**Observations, ref ASHRAE May 2013 Journal article Vol. 55, NO 5, pg. 18
“VAV Reheat vs. Active Chilled Beams & DOAS”.**

Prepared by: S. A. Mumma, Ph.D., P.E., [ASHRAE Distinguished Fellow \(DFASHRAE\)](#)
Penn State College of Engineering Professor Emeritus

Criteria necessary to meet the space latent loads

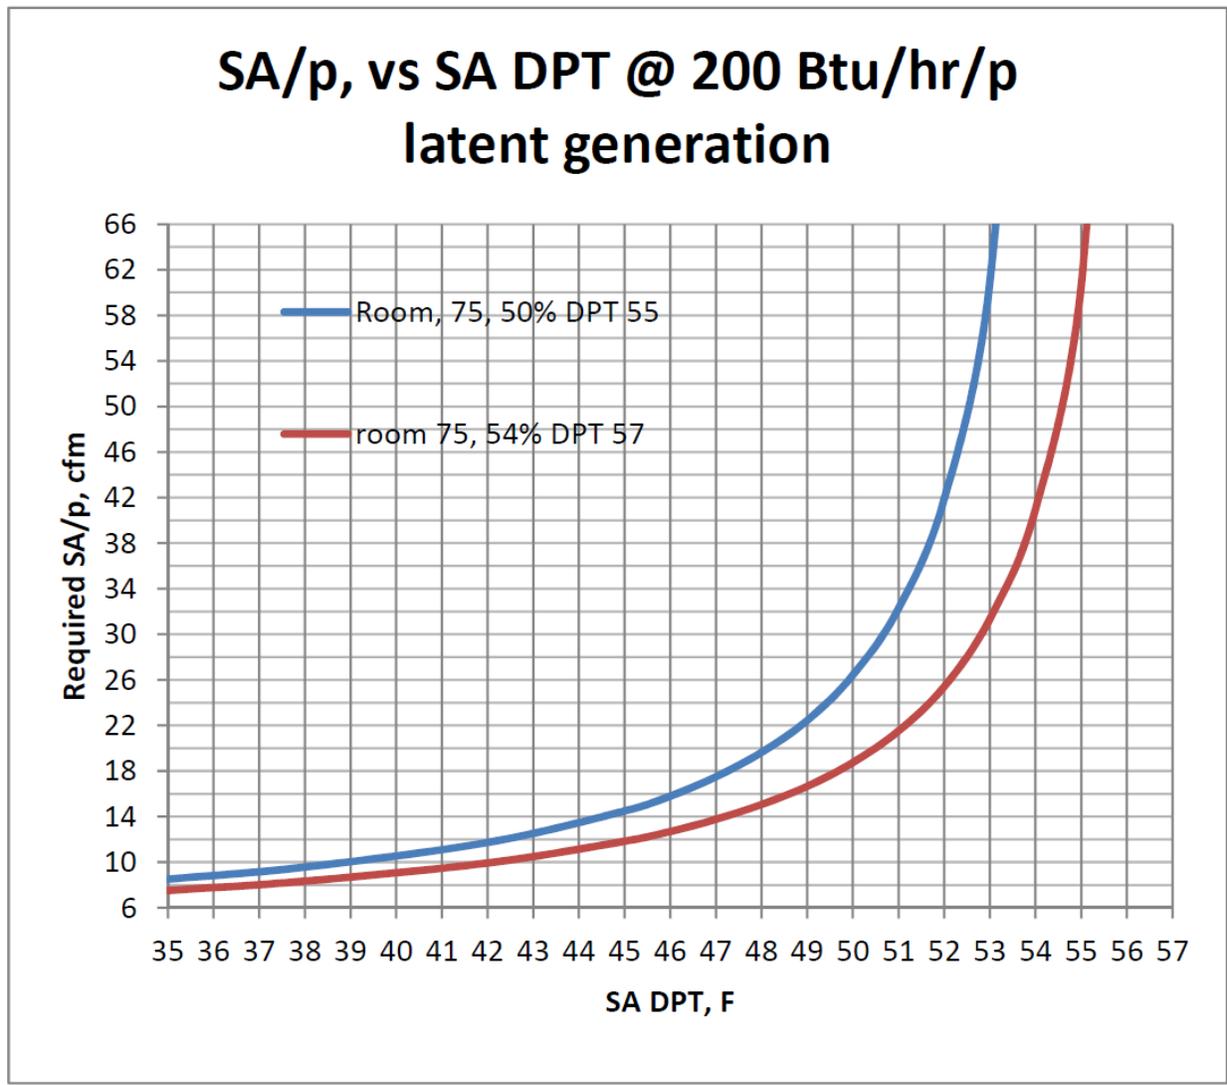
If we assume that the building design and operation preclude infiltration, then the internal latent load is essentially occupancy based. If we assume that the latent load for moderately active office workers and non-sleeping engaged students are about 200 Btu/hr, and that for condensation control the space is maintained at 75 F DBT and 50% RH (humidity ratio of 64.9 gr/lbm).

Solving $Q_L/p = 0.67 \cdot \text{scfm}/p \cdot (W_{\text{space}} - W_{\text{supply}})$ for W_{supply} , [$200 = 0.67 \cdot 17 \cdot (64.9 - W_{\text{supply}})$], one gets $W_{\text{supply}} = 47.3$ gr/lbm (i.e. required SA DPT= 46.7F) with the office flow rate per person of 17 scfm. At the classroom ventilation flow rate of 8.5 scfm/person, the computed $W_{\text{supply}} = 29.8$ gr/lbm (i.e. required SA DPT= 34.9 F). The article does not provide the design SA DPT, but since there is just one DOAS unit, all spaces receive the same DPT. If so, in order to remove the occupant generated latent load in the highly variable occupancy classrooms, and maintain the space DPT around 55F to avoid ACB condensation, the OA to the classrooms must be increased from 8.5 to 17 scfm/p, i.e. doubled. The result of this step would be to increase the total flow for the DOAS from 13,574 to 23,946 scfm.

Commonly, the cooling water to ACBs is held about 2 F above the design space DPT. While not stated in the article, it is assumed that space design DPT is 55 F for condensation avoidance since 57 F cool water is supplied to the ACBs. Employing the relationships above, it is easy to compute the required SA per person for latent load control. The figure below illustrates this relationship. As the SA DPT increases, the required SA flow increases rapidly approaching infinity. The ASHRAE Std. 62.1 default occupancy density, noted in the table above, yields 188 people in offices, and another 1,225 in classrooms for a total building head count of 1,413 occupants. With a published constant volume DOAS design flow of 33,900 scfm, the resulting SA flow rate per person is 24 scfm. At 24 scfm/p, the SA DPT required to maintain a space DPT of 55 F is 49.4 F. This SA DPT is difficult to achieve with the 45 F CHWS published in the article. **Note:** the majority of DOAS designs do not have access to a campus chilled water system, and hence use DX DOAS (generally equipped with exhaust air energy recovery rather than passive dehumidification wheels) that can easily deliver the

In order to drop the SA DPT, when supplying just the Std 62.1 required 17 scfm/person (as opposed to the design 24 scfm/p), to 46.7 F using 45 F CHWS with assurance would seem to suggest the introduction of a **passive dehumidification wheel** in the DOAS unit. In that combination, 51 F saturated air (enthalpy of 20.85 Btu/lbm) leaving the CC served with 45 F CHWS would be nearly adiabatically dried and heated to the required 46.7 F SA DPT with an approximate leaving DBT of 56 F. Introduction of the passive dehumidification wheel eliminates concern about chiller energy performance degradation when required to produce approximately 46F SA, and the associated fear of condensation in the ductwork and ACBs if supplied with 46F DBT air.

One of many alternative ways to handle the space sensible and latent loads in the CLASSROOMS.

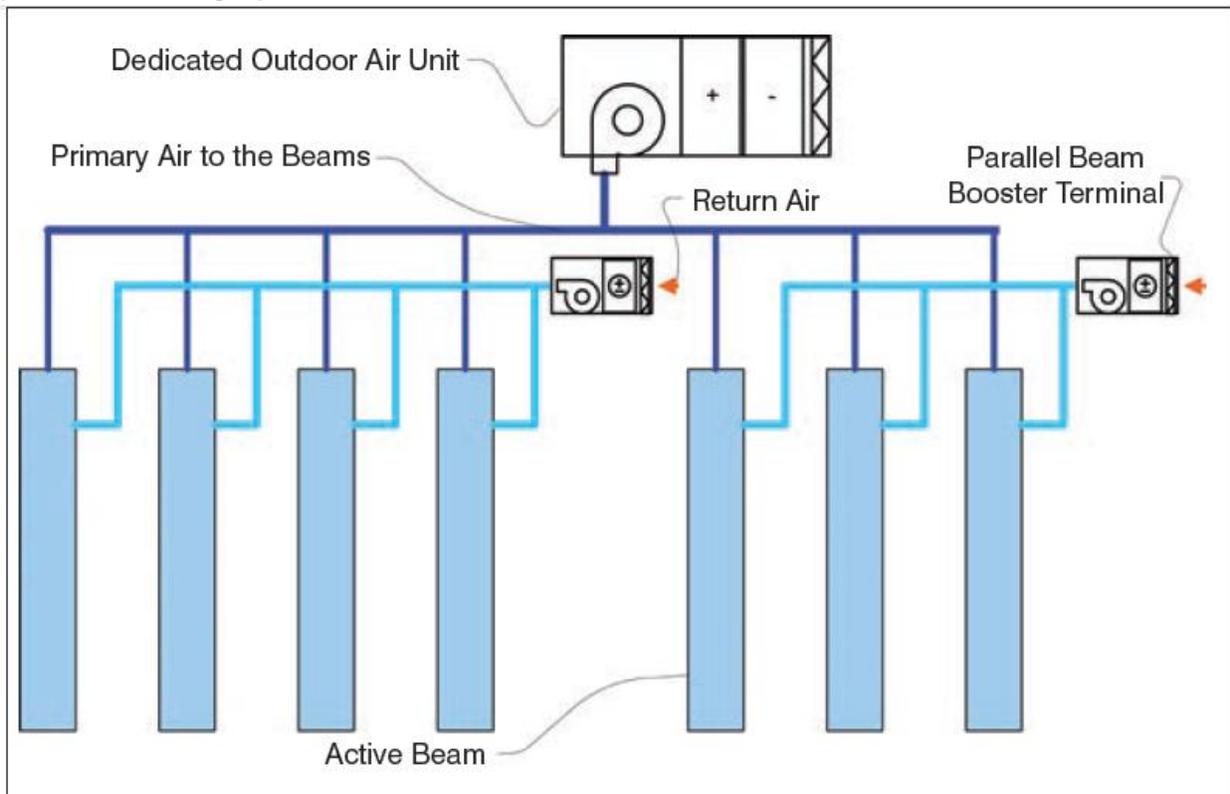
Classrooms are generally highly variable occupancy density facilities. As such they should be equipped with demand controlled ventilation to both conserve central cooling and heating energy use as well as terminal reheating energy. Unfortunately, to avoid or minimize terminal reheating, many designers are of the persuasion that the DOAS air should be centrally tempered, as was done by the ACB designers in the article, i.e. the constant volume primary air was delivered at a constant 63F. This introduces a serious energy penalty, as well as a first cost penalty reflected by the added cooling capacity required and sensible cooling terminal equipment. The consequences of this elevated SA DBT, i.e. 63F as opposed to the 50F necessary for latent control, will be discussed later.

When a DOAS unit equipped with passive dehumidification delivers 17 scfm/p (1.1 scfm/ft²) of air at the required 46.7 F DPT (associated supply DBT of 56 F), its sensible cooling capacity essentially equals that of an ordinary VAV system supplying 55F DBT air. In other words, there is more than enough capacity to obviate the elimination of ACB in the classrooms. Once the beams are gone, ACB condensation issues in the classrooms are eliminated, and the space DPT can be allowed to rise to 65F (84.7 gr/lbm). Using the above equation $[200=0.67*scfm/p*(84.7-47.3)]$ to solve for the new scfm/p, one finds that only 8 scfm/p is required to meet the space latent load.

Conclusion, the classrooms can be supplied with the DOAS air as necessary to meet the space sensible loads employing its own variable volume SA delivery arrangement that also uses DCV. And as noted above, since the DOAS supply air DBT essentially equals that of a conventional VAV system, any proclaimed fan energy penalty is eliminated. Further, the DOAS will always use less terminal reheat to meet the ventilation requirement compared to conventional VAV when in the recirculation mode. Example, let's say a space needs 100 scfm of ventilation air, which is that supplied by a DOAS, but a conventional VAV recirculation system using 50-80% completely viciated recirculation air needs to supply 200 to 500 scfm of SA (100/0.5 to 100/0.2) to the room to actually deliver 100 scfm of OA. In the conventional VAV, all 200-500 scfm are subject to terminal reheat, not just the necessary 100 scfm supplied by a true DOAS.

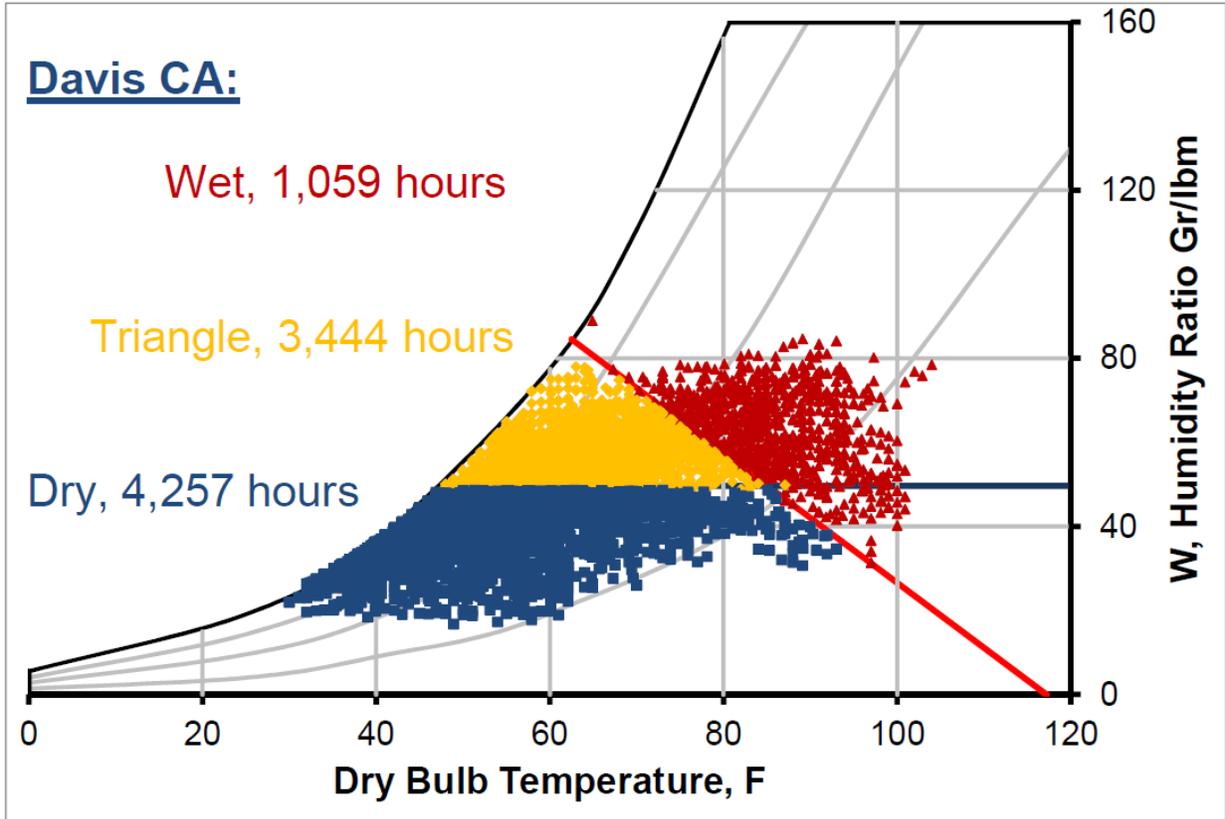
The project discussed in this article is located in Davis, CA, a location extremely climate friendly compared to virtually all locations east of the Rockies where 80% of the USA population lives. Engineers designing for this area of the USA, largely dominated by conventional VAV systems, virtually never have a concern for humidity problems. This paradigm must change when the design uses ACBs. A plot of the 8,760 hours of weather data is presented below.

The climate is temperate with just a few hours where the DBT drops below 40F, and it is relatively dry where the humidity ratio rarely even reaches 80 gr/lbm. Many of us living east of the Rockies see both sub 0 F winters, and summers with the humidity ratio above 140 gr/lbm for a great many hours. As a result, the utility of exhaust air energy recovery differs vastly East to West. In climates like Davis, where the OA humidity ratio is below that needed to take care of the entire space latent loads for half the year, the DOAS SA controls need to reset the SA DBT during these hours to just meet the critical space sensible cooling loads (see these links: <http://doas.psu.edu/OR-05-3-3.pdf>, & [http://doas.psu.edu/DOAS Field Experience Denver 05 2 1.pdf](http://doas.psu.edu/DOAS_Field_Experience_Denver_05_2_1.pdf)).
